ANN ARBOR HISTORIC DISTRICT COMMISSION

Staff Report

ADDRESS: 1667 Broadway Street, Application Number HDC16-156

APPLICATION: The applicant seeks HDC approval to demolish a 210 square foot non-architecturally significant rear addition and construct a new 757 square foot rear addition and carport, and other related work.

EXISTING FIRST FLOOR PLAN
scale: 3/32" = 1'-0"

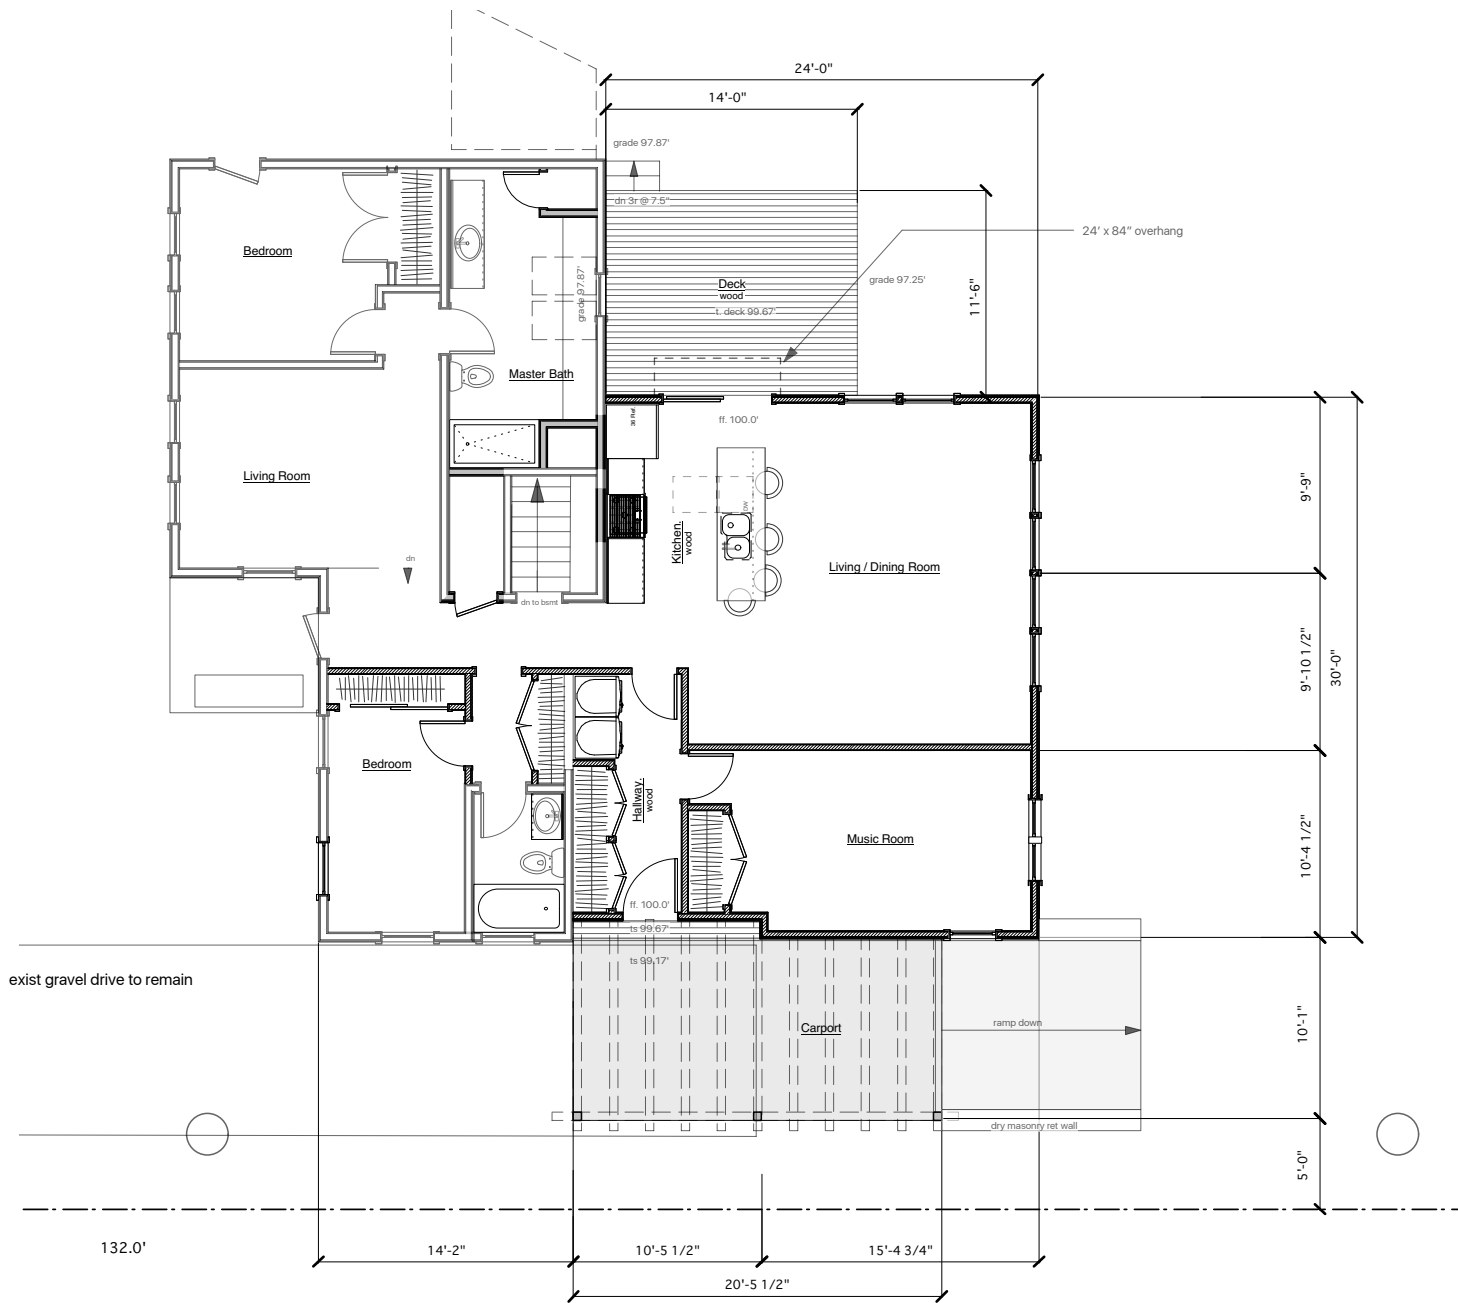
3. Per the city assessor, the current floor area is 1,032 square feet. Of that, 210 square feet is the rear wing, which will be demolished. The proposed addition is 757 square feet. The current house minus the rear wing plus the addition results in a 1,579 square foot house, for a net increase of 53%. (Note that these calculations are different than the ones in the application, because those assume that the rear wing is a post-1945 addition. That drives the floor area percentage up significantly.)

Proposed East Elevation

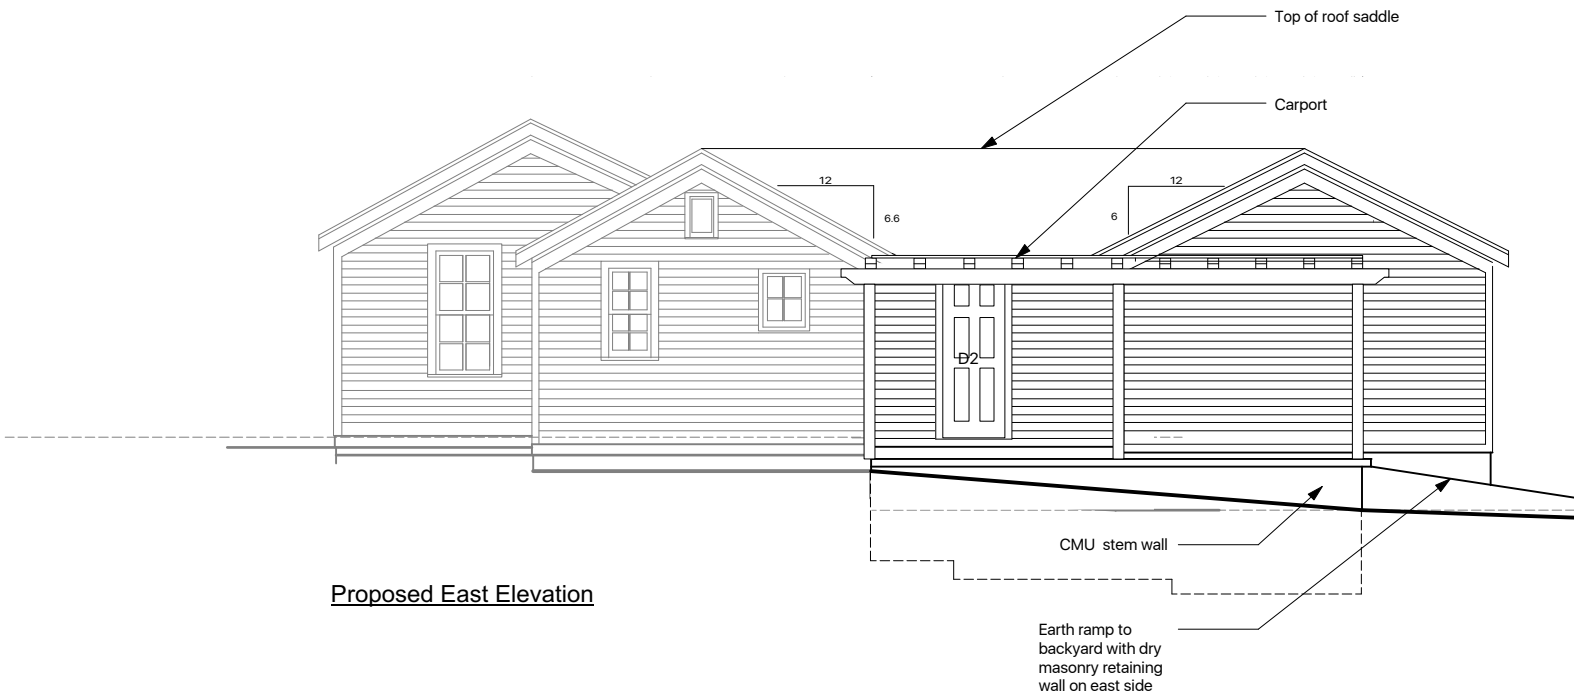
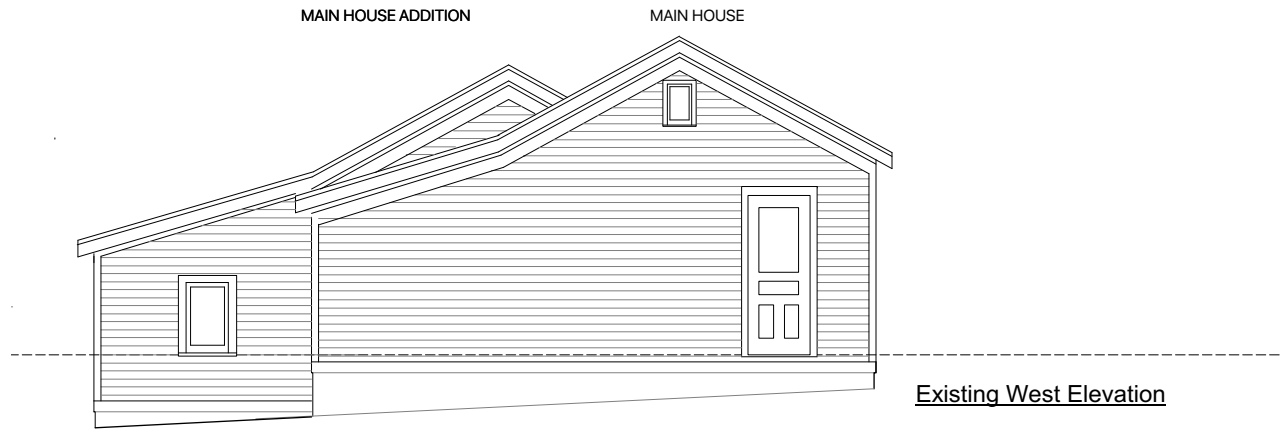
4. The addition is essentially a 24' x 30' rectangle behind the house. Where it meets the back of the east elevation (the driveway side) a section of exterior wall will be inset slightly (about a foot) to preserve the rear corner of the original structure and act as a visual separation between a new east-facing gable at the back of the addition. This design is repeated on the west elevation of the addition, though it is inset 14' from the northwest corner of the historic structure. The addition's roof ridge matches the height of

5. The east side elevation of the addition also incorporates a wood trellis-style single-car carport over the existing driveway. The carport is behind the historic structure (off the new addition). Staff has some slight reservations about a carport in such close proximity to the historic structure, but the design does provide maximum transparency and would be more than 50' from the street, so the impact would likely be nominal.

Proposed North Elevation

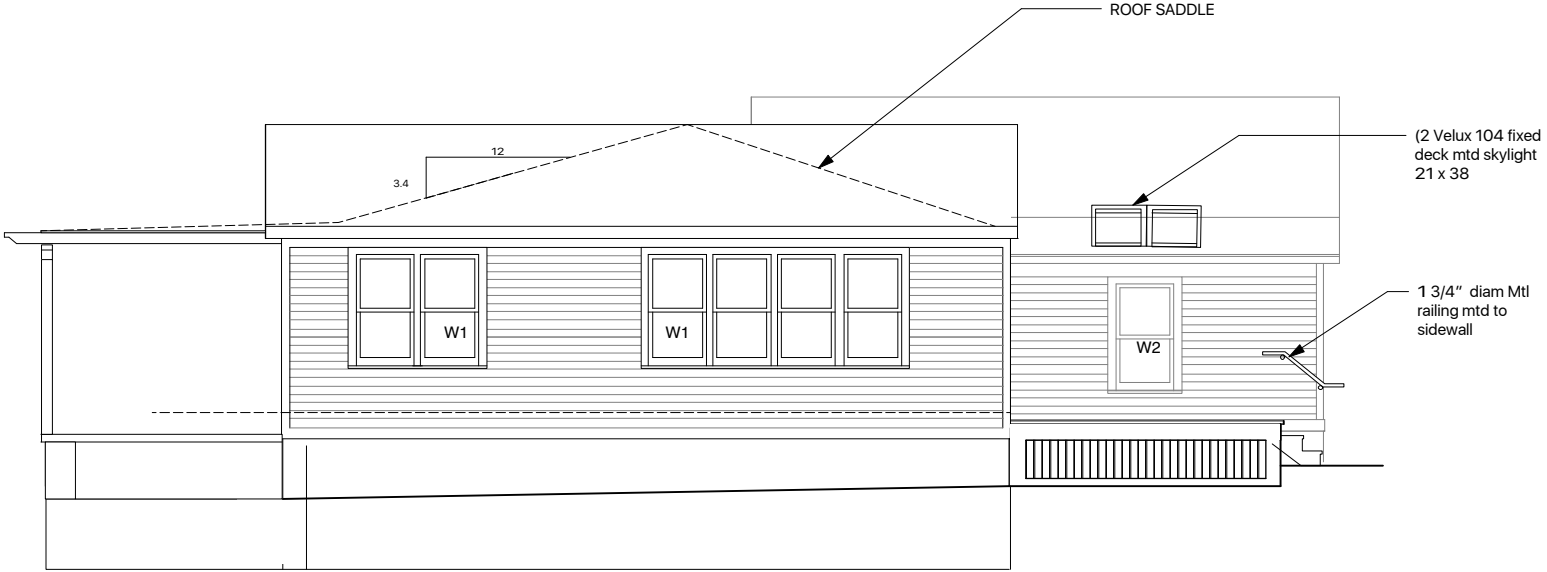
6. Two skylights on the rear-facing main roof and a low, wood rear deck are appropriate in size and scale and invisible from the public right of way. A one-over-one modern double-hung window would be replaced with a new one on the main house's rear elevation. Two six over six windows on the rear elevation would be removed for the addition. The age of the windows is unknown, though they are old, but they do not match the age and proportions of the rest of the historic windows on the house.
